QA-50 #1  
4/25/72

# SERVICE BULLETIN

## MODIFIED SHIFTING MECHANISM

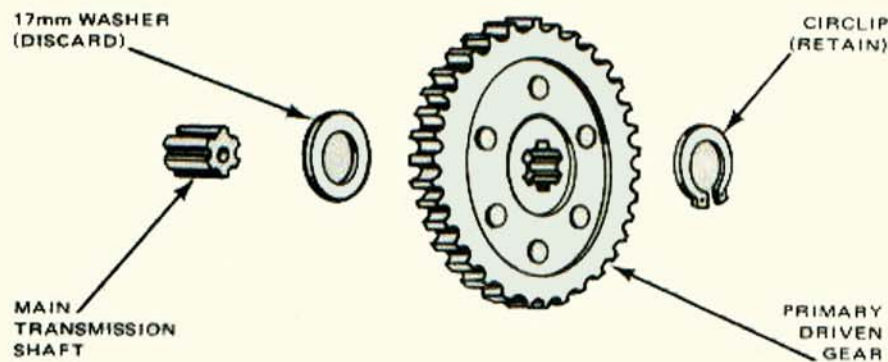
1. Drain engine oil and remove the following:
  - Kick Starter Pedal
  - Exhaust System
  - Right Crankcase Cover
2. Remove clutch assembly as described in shop manual.
3. Remove change pawl shaft flange and spring from gear change pawl shaft, as described in shop manual. Discard spring.

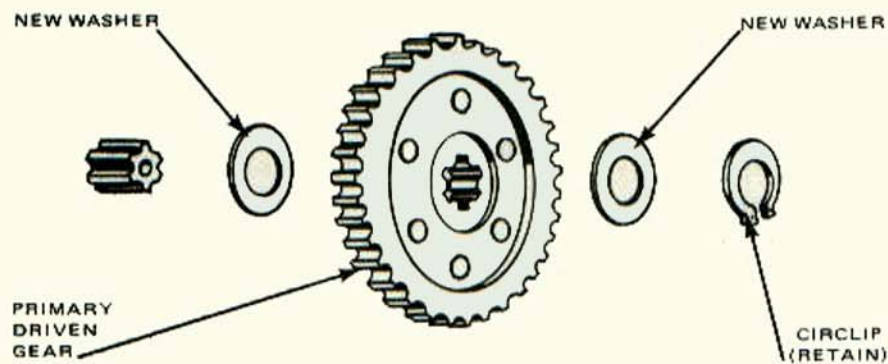
4. Remove primary driven gear as described in shop manual.
5. Remove and discard 17mm thrust washer P/N 90451-081-000 from main transmission shaft.

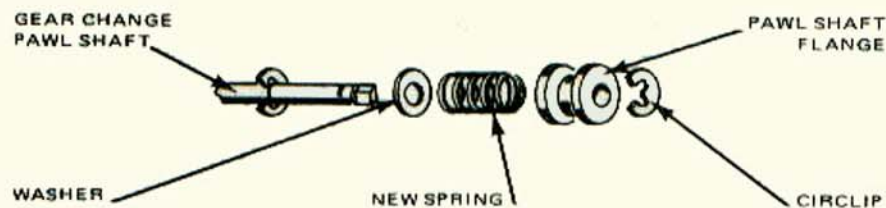
6. Reinstall primary gear on main transmission shaft, placing one new thin washer P/N 90411-001-000 from the kit, on each side of the gear. Reinstall existing circlip.

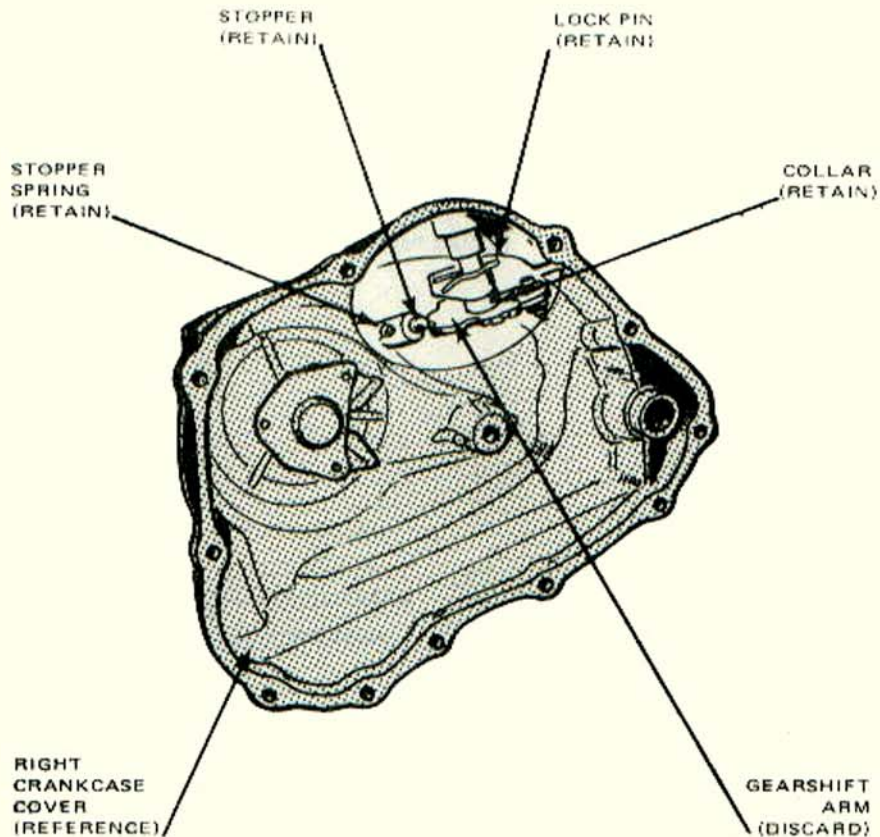
7. Reinstall parts on gear change pawl shaft as described in shop manual, using new spring P/N 24209-114-010 from kit.
